**Rainforest Recovery Flooring Installation**

**BID No. E11-121**

**ADDENDUM NO.: THREE**

**DATE ADDENDUM ISSUED: November 8, 2010**

Floor Plan - DEMO - EXISTING CONDITIONS

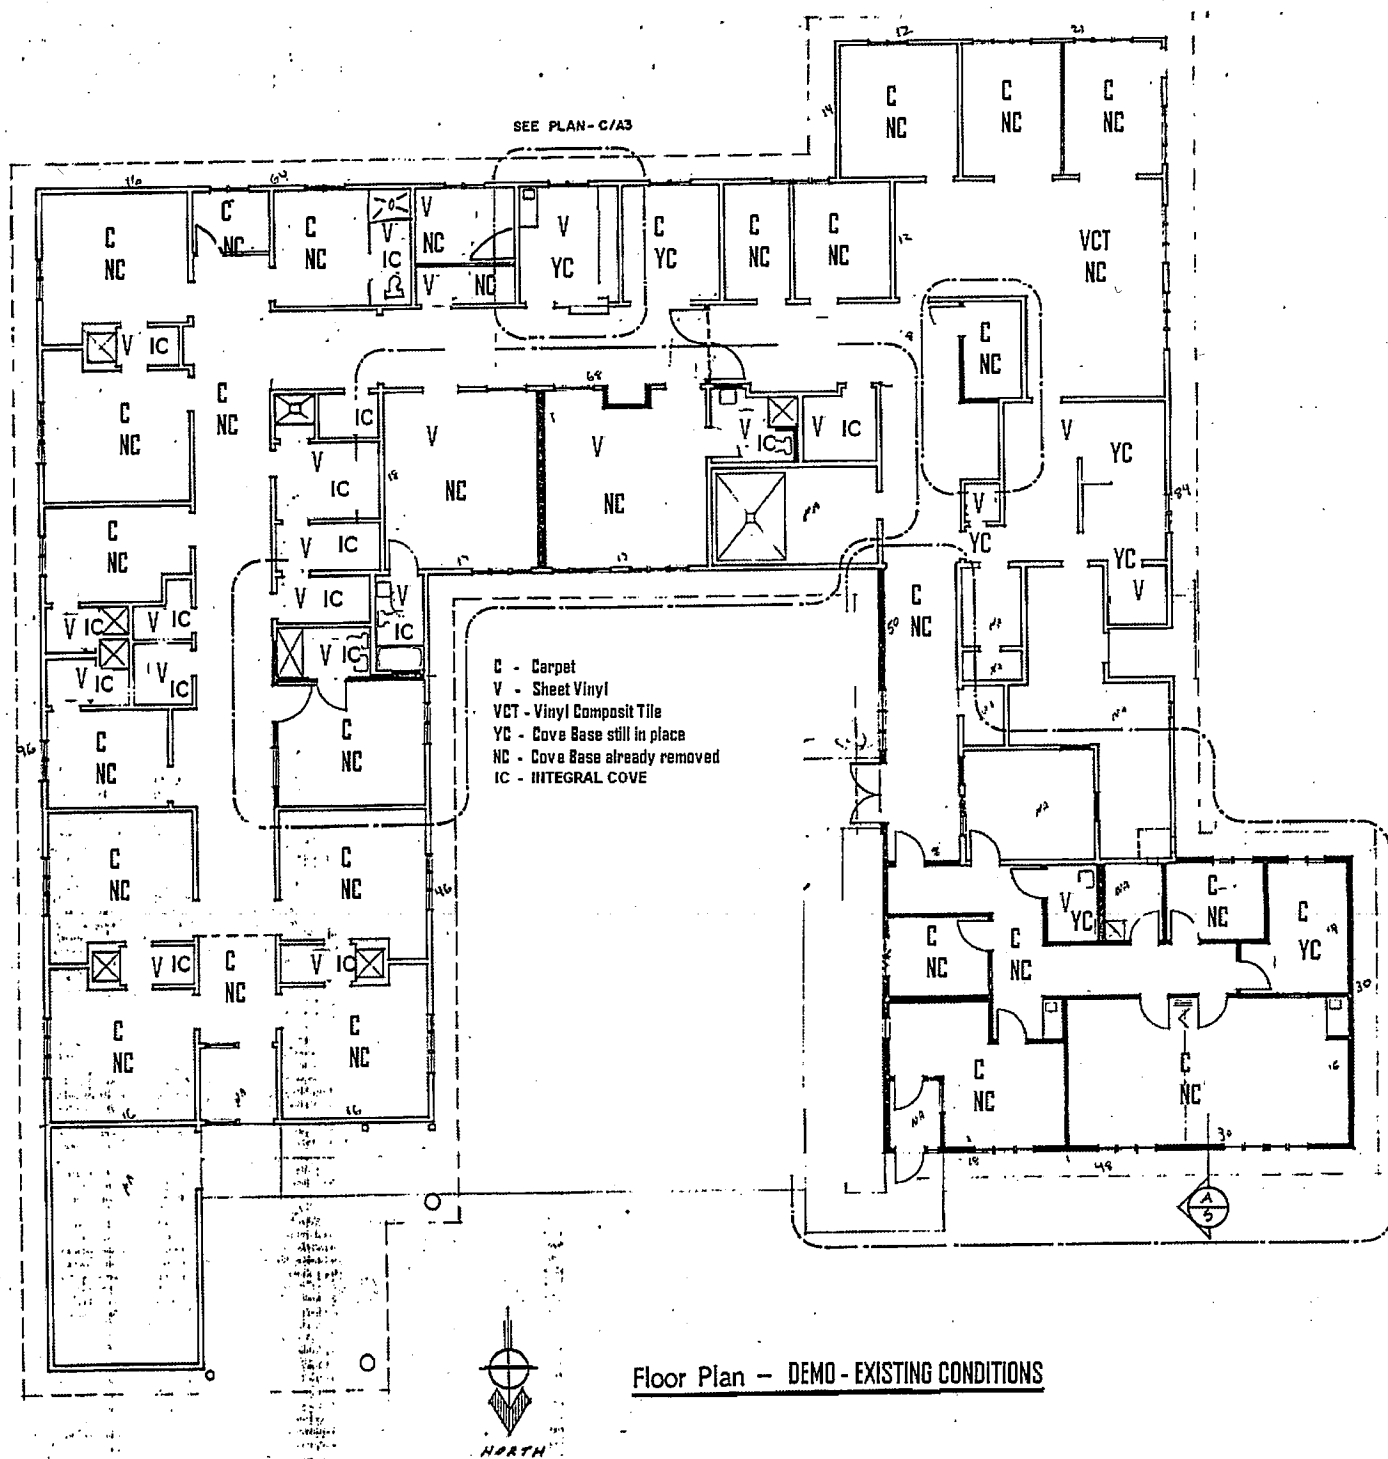
- Bartlett Regional Hospital (BRH) has a negative air machine that can be made available to the Contractor for the duration of the contract.
- BRH staff will be responsible for removing furniture in rooms.
- The attached drawing indicates existing flooring in rooms included in this Project. This drawing should not be used for scaling any room dimensions.
